Reply to Reviewer 1

Manuscript title: A global terrestrial evapotranspiration product based on the three-temperature model with fewer input parameters and no calibration requirement

Reviewer: 1

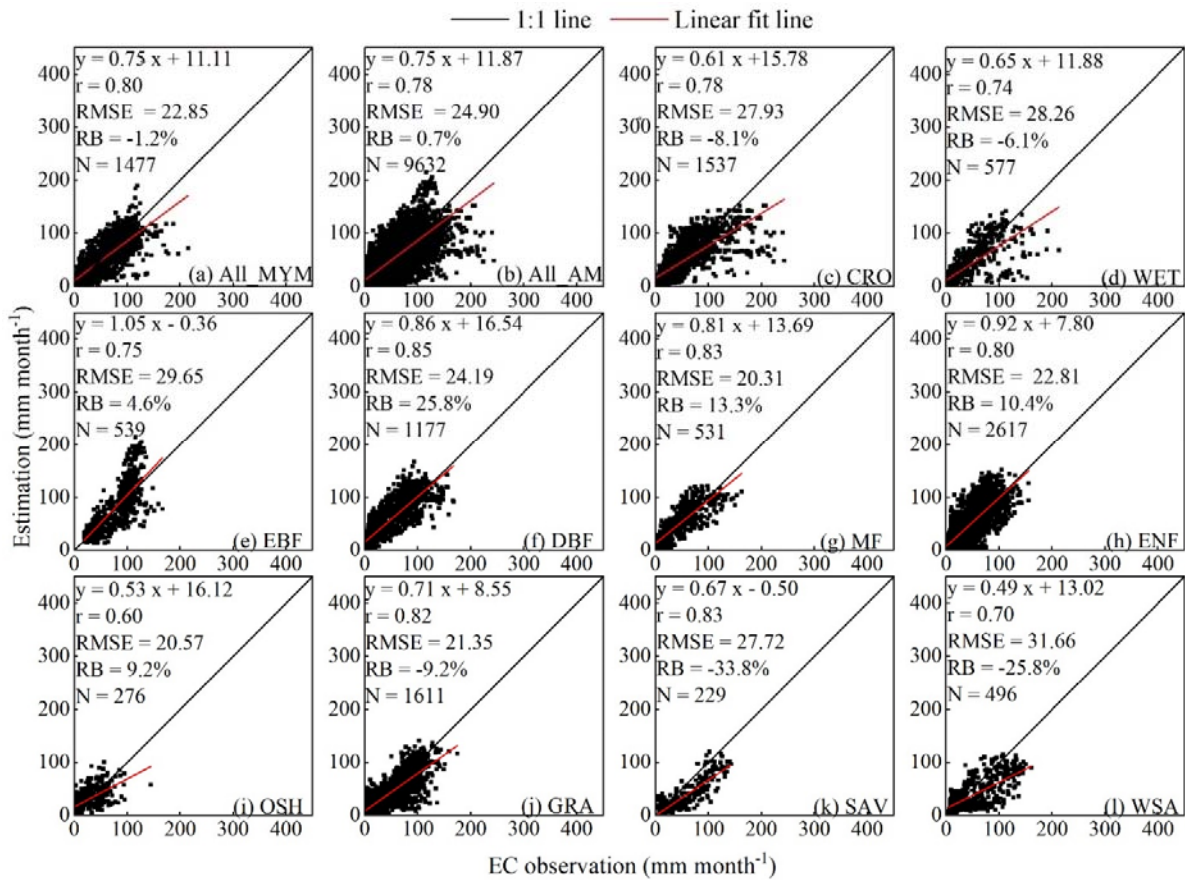
16. Texts in the figures are too small to read. I suggest the authors enlarge these texts to improve their quality and readability.

We tried our best to improve the quality of the figures, including the enlarged text in Figures 2, 4, and 5. Figure 2 (Figure 3 in this revision) shows an example as follows:
